Re: *Draft Fifth Five-Year Review Report for Former Sudbury Training Annex for AOC A7, Sudbury, Massachusetts*

**Final**  
**FIFTH FIVE-YEAR REVIEW REPORT (2016-2021)**  
**for**  
**Former Sudbury Training Annex for AOC A7**  
**Sudbury, Massachusetts**

**FIFTH FIVE-YEAR REVIEW REPORT (2016-2021)  
for  
Former Sudbury Training Annex for AOC A7  
Sudbury, Massachusetts**

Figure  
1

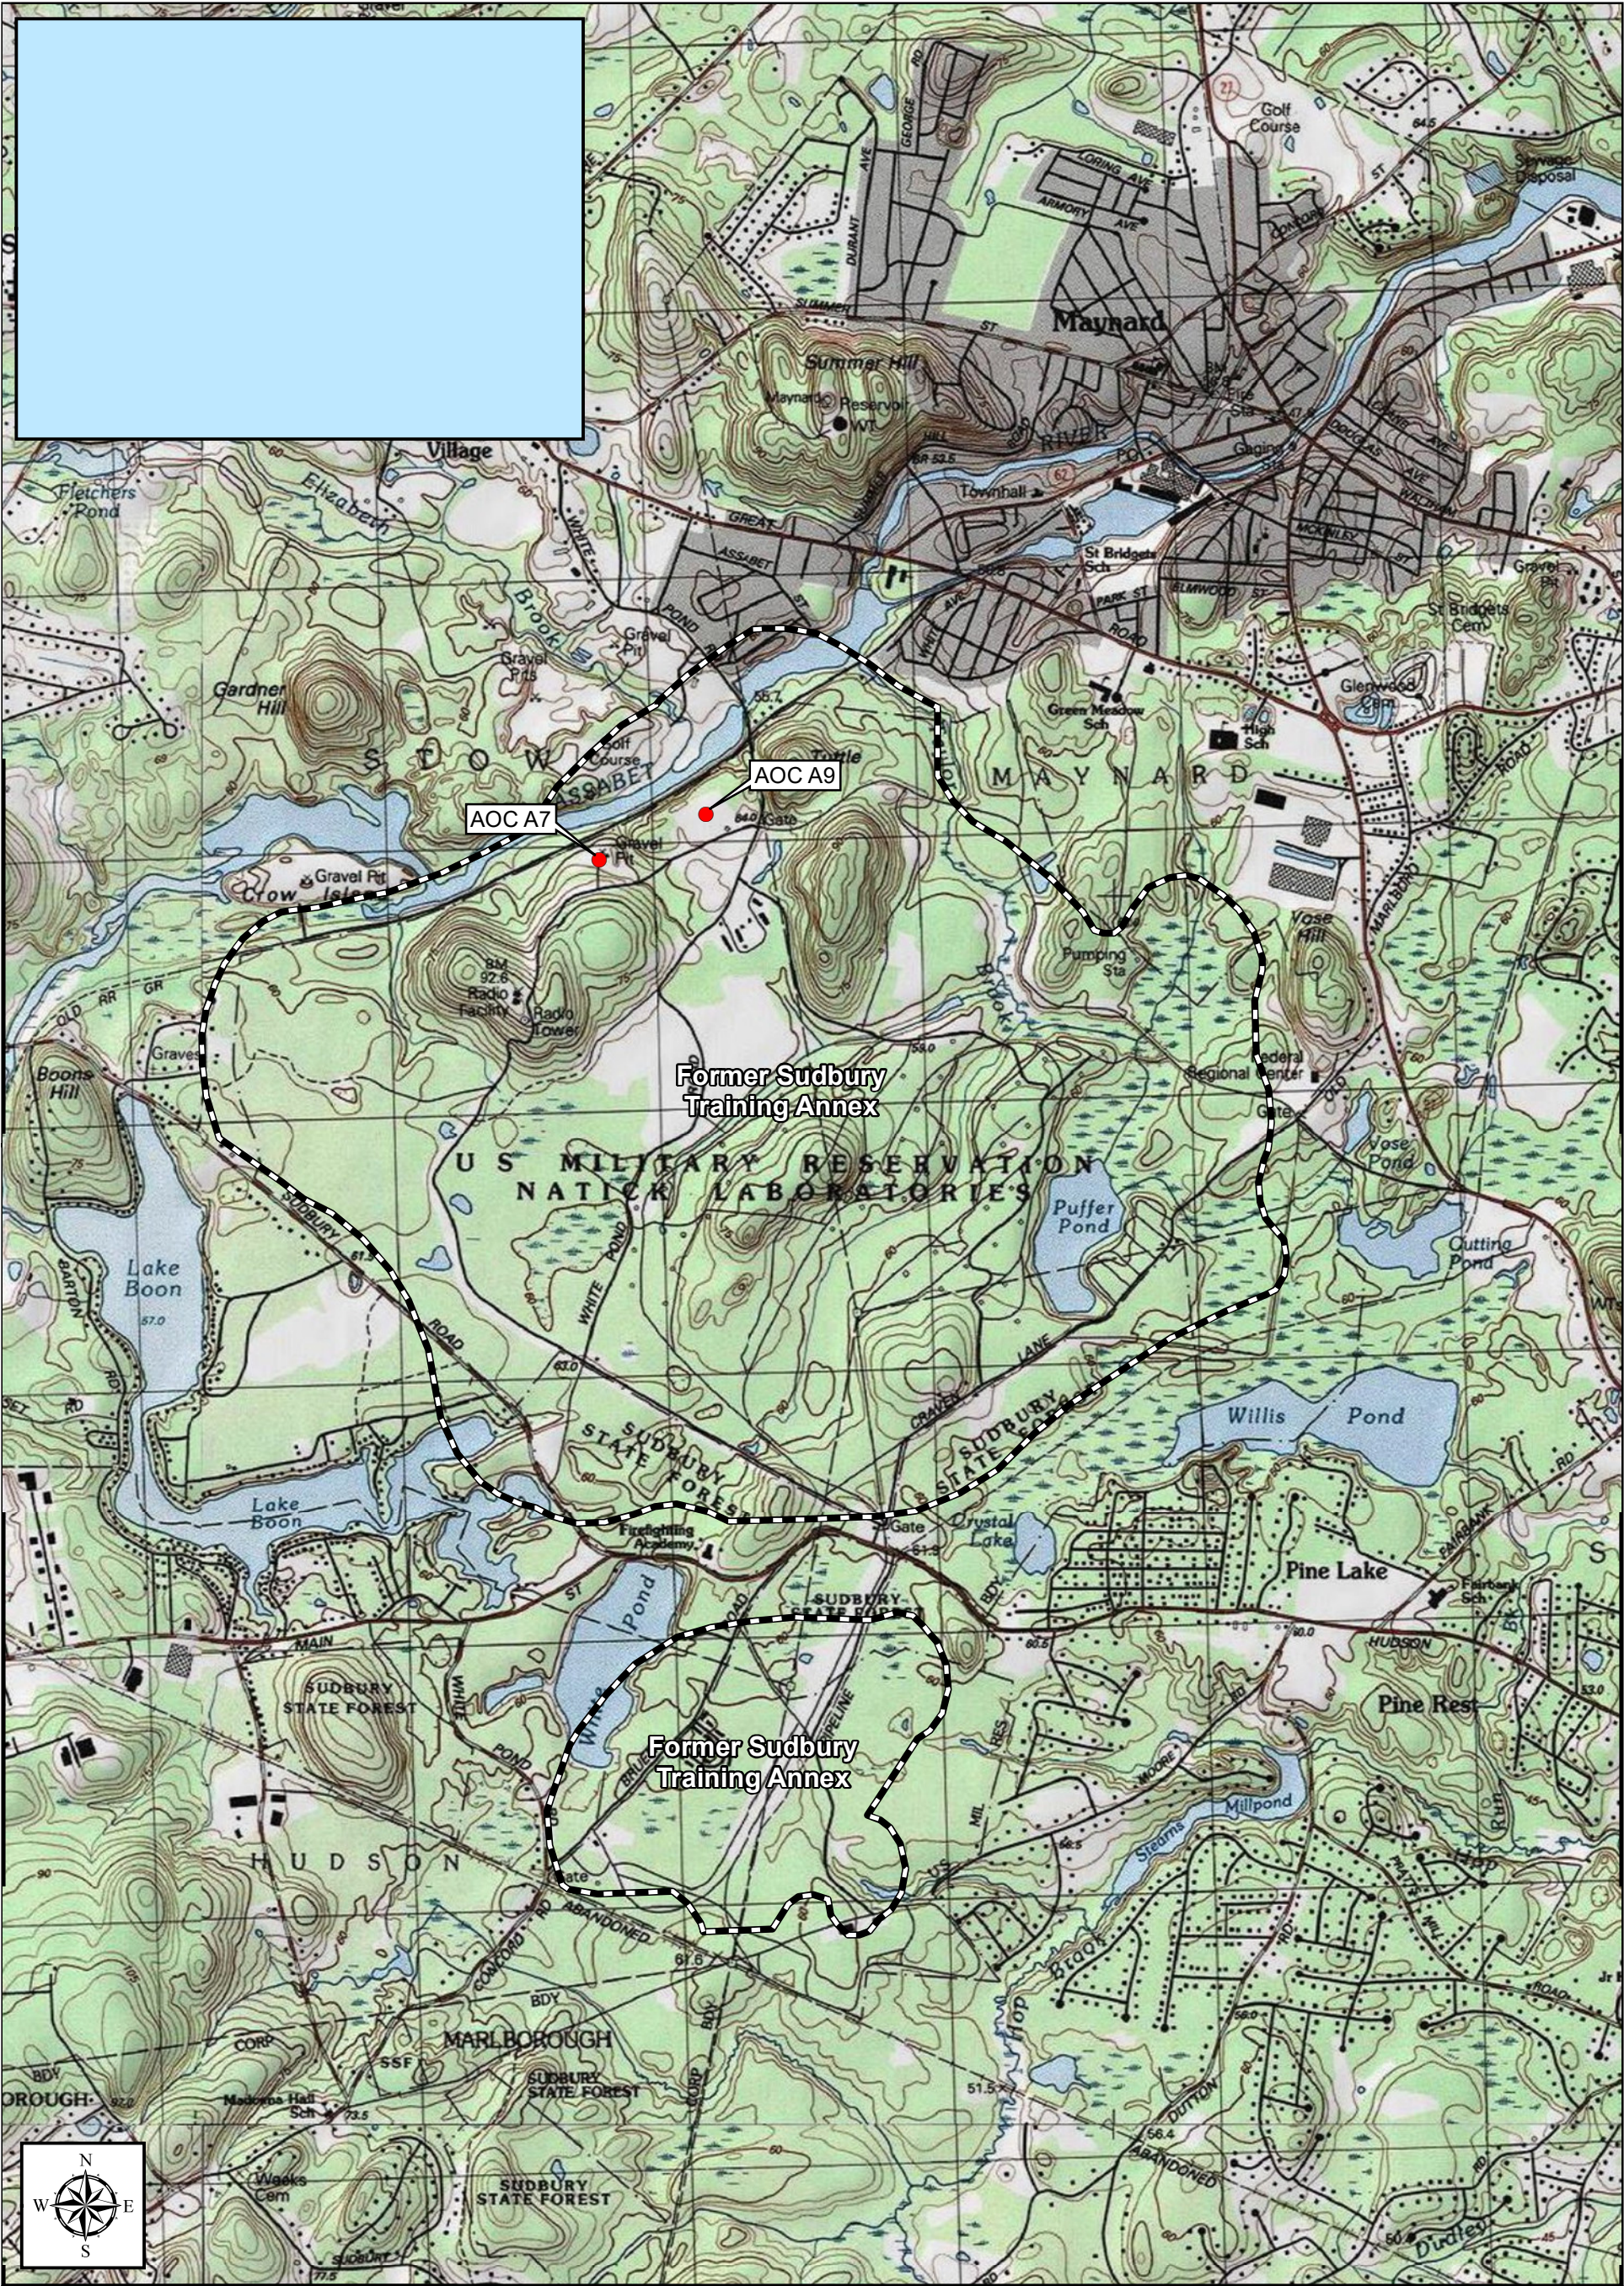
**EPA Specific Comment 45:** Figure 1 & 2 – P13 is shown on Figure 7. As PFAS Add P13 to figure.

**Army Response:** P13 is shown on Figure 7. As the PFAS investigations are not part of the AOC A7 FYR, P13 was not included into the introductory figures of the FYR.
